APPLICATION NO.	FILING DATE	FIRST NAMED INVENTOR	ATTORNEY DOCKET NO.	CONFIRMATION NO.
10/691,503	10/24/2003	Yasuaki Kuwata	117604	7211
25944	7590	01/11/2007	EXAMINER	
OLIFF & BERRIDGE, PLC P.O. BOX 19928 ALEXANDRIA, VA 22320			NGUYEN, PHILLIP	
			ART UNIT	PAPER NUMBER
			2828	
SHORTENED STATUTORY PERIOD OF RESPONSE	MAIL DATE	DELIVERY MODE		
3 MONTHS	01/11/2007	PAPER

Office Action Summary	Application No.	Applicant(s)	
	10/691,503	KUWATA, YASUAKI	
	Examiner	Art Unit	
	Phillip Nguyen	2828

DETAILED ACTION

With respect to claim 3, see Fig. 2F-2H for the central portion on top of the mirror 22.

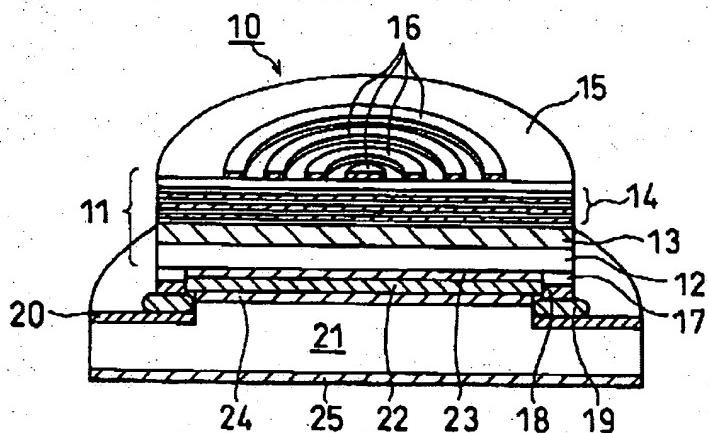
With respect to claim 1, Koyama discloses in Fig. 2 a surface emitting semiconductor laser, comprising: a laminate of semiconductor layers (10-26) emitting multimode laser light; and a block member blocking light of at least a fundamental mode among the multimode laser

light emitted from the laminate the block member being provided separate from an electrode provided on a top of the laminate (paragraph 0024).

With respect to claim 2, Koyama discloses the laminate semiconductor layers comprising a substrate 10, a lower mirror 12 on the substrate, an upper mirror 22, an active region (between the lower and upper mirrors), and a current confinement layer 32, the active region and the current confinement layer being interposed between the upper and lower reflection mirrors; and the block member is provided in an emission aperture provided above the upper reflection mirror (also see paragraph 0024).
